DTT 2024 THM-DIA Conceptual Design Review Meeting

Tomography and Imaging

June 10 – 12, 2024 - Bruno Brunelli Hall, ENEA Frascati
DTT-THM-DIA Conceptual Design Review Meeting

DTT Consortium (DTT S.C.a r.l. Via E. Fermi 45 I-00044 Frascati (Roma) Italy)

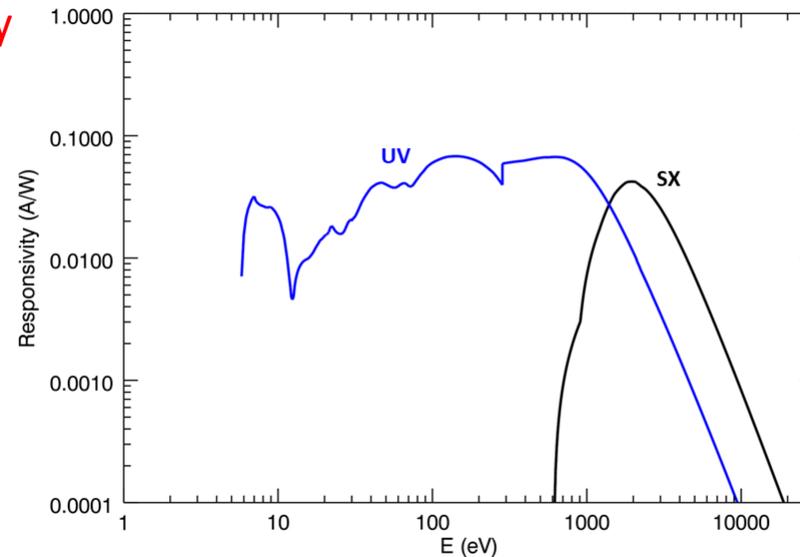
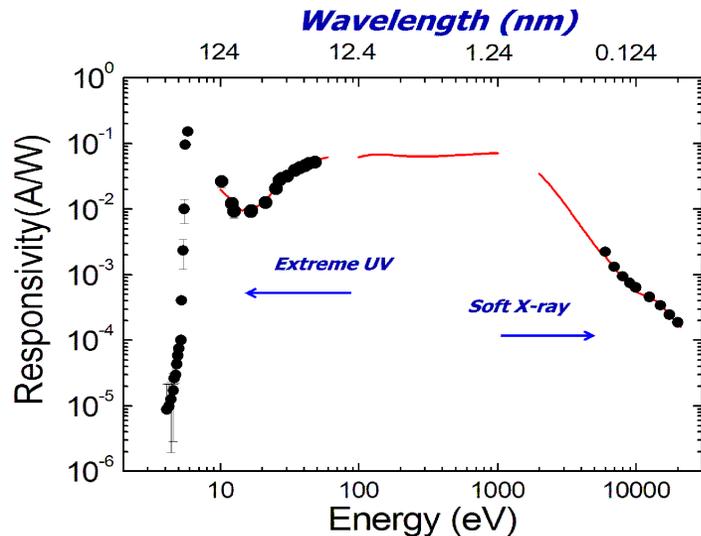
What is the effects of stray ECH on diamonds? Is shielding required?

- Shielding is planned for the electrical noise on the (Kapton coated?) cables in-vessel; it is not expected to be a problem for the additional thermal load (to be checked) nor spurious signal

Responsivity 2/2

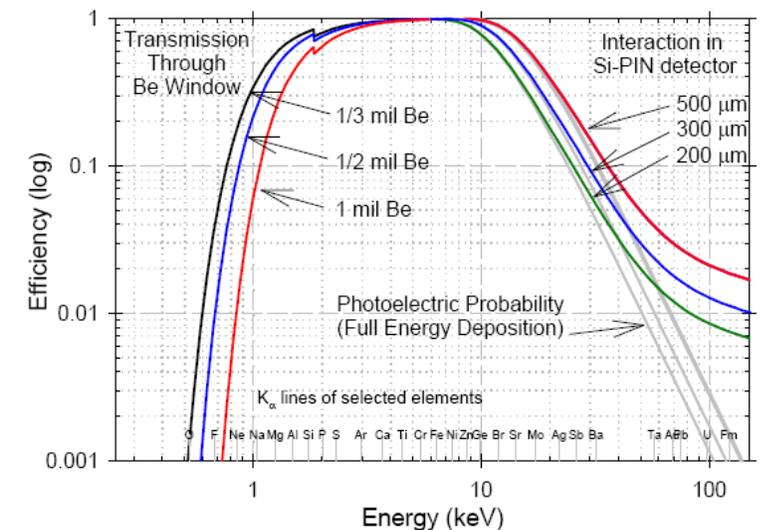
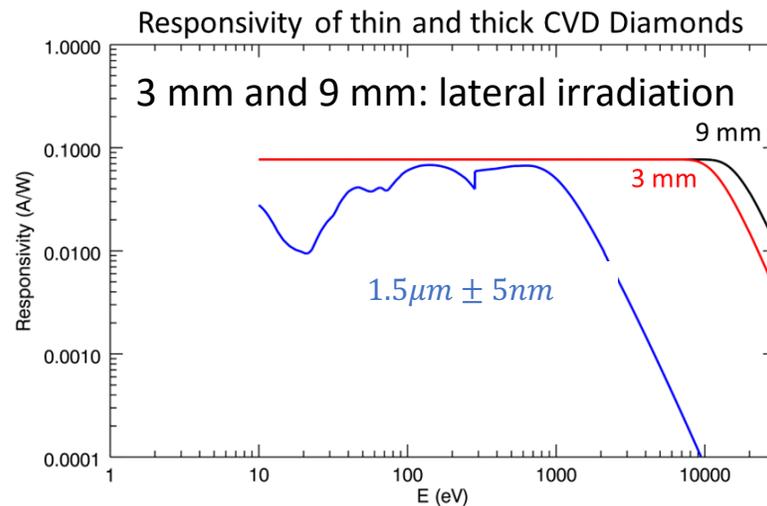
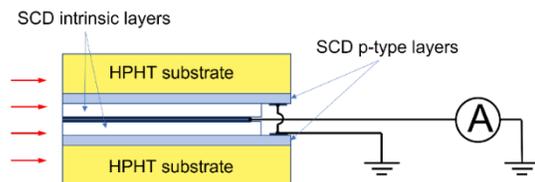
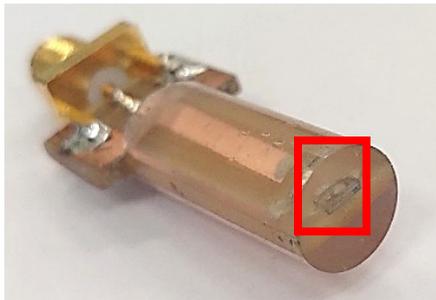
- Bandwidth (0.5 eV-30 keV) seems too large. Kapton could be incompatible with stray ECH. Have you foreseen to protect it?
- If a filter is introduced to reduce the spectral range of the CVD detectors the effect of stray ECH on it must be considered
- Commercial diodes costs much less. It must be evaluated the cost of beryllium windows and shielding from stray ECH.

The LAT configuration (=lateral irradiation) extends the spectral range to about 30 keV. This layout needs to be further validated and will not require filters to cut off the low energy part of the plasma emission.

- Si diodes have similar high energy limit and are bigger;
- They are cheaper but will die faster

Tangential Imaging Conceptual design (PHASE 1)

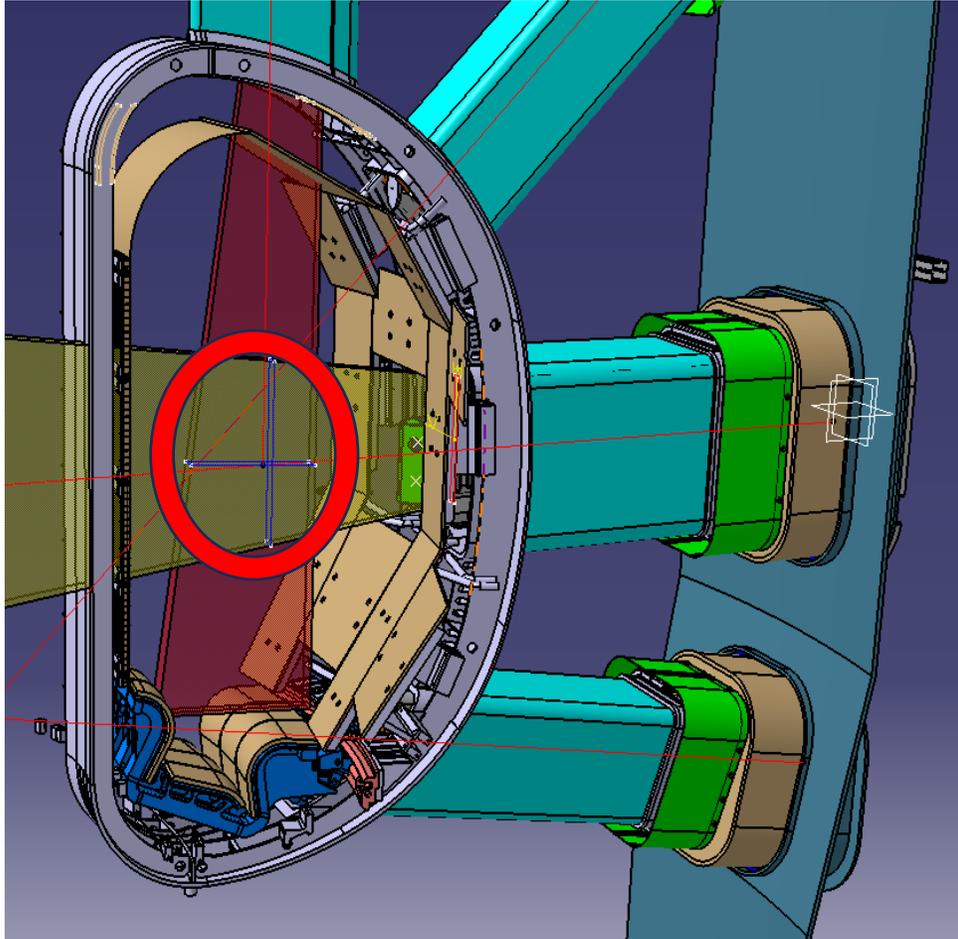
- The imaging system requires the other two cameras (not available in phase1) to provide useful information. Having different spectral range of CVD tomography, also this system cannot be used for the GEM data deconvolution, so it seems appropriate to **move it to phase 2** diagnostics.

Answer: a tomographic reconstruction will be provided by the CVD diamond array which works in the 5.5-30 keV range and is therefore suitable for the deconvolution of the tangential GEM. In any case, given the absence of other X-ray diagnostics and its features such as high sensitivity, adjustable spatial (5-10 mm on plasma) and temporal resolution (sub-microsecond in macrozones), post-processing flexibility, a wide dynamic range, energy discrimination and immunity from noise , **we reaffirm its validity.**
